**From:** [HS2Enquiries](#)  
**To:** "Jim Conboy"  
**Subject:** RE: Error in the AP4 ES TR-001-000  
**Date:** 27 October 2015 11:13:00  
**Attachments:** [image002.png](#)  
[image005.png](#)  
[image003.png](#)

**To:** HS2Enquiries  
**Cc:** Widdows, Sarah  
**Subject:** Error in the AP4 ES TR-001-000

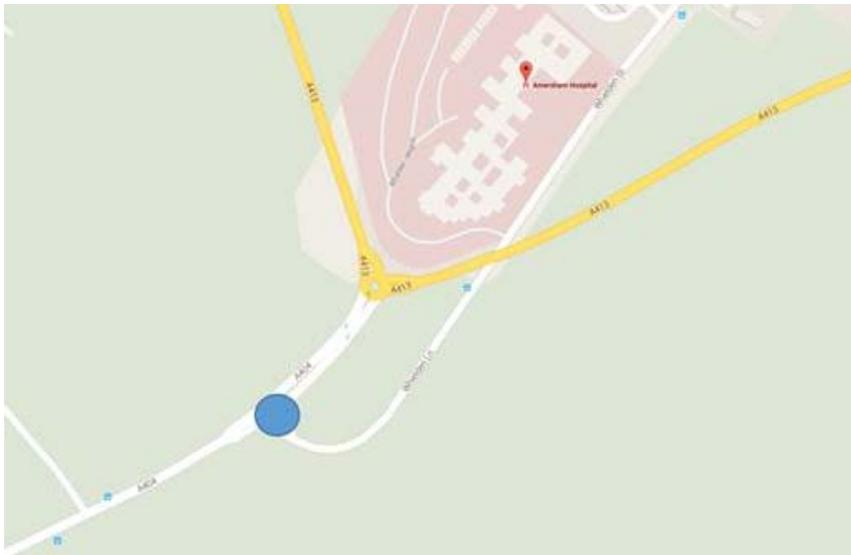
*Table 7-33.4 describes the junction with Whielden Lane (the road on which Amersham hospital stands) and the main A404 Amersham-High Wycombe road.*

Correct, it relates to the junction below. The results presented and supporting text in paragraph 3.2.25 are correct.
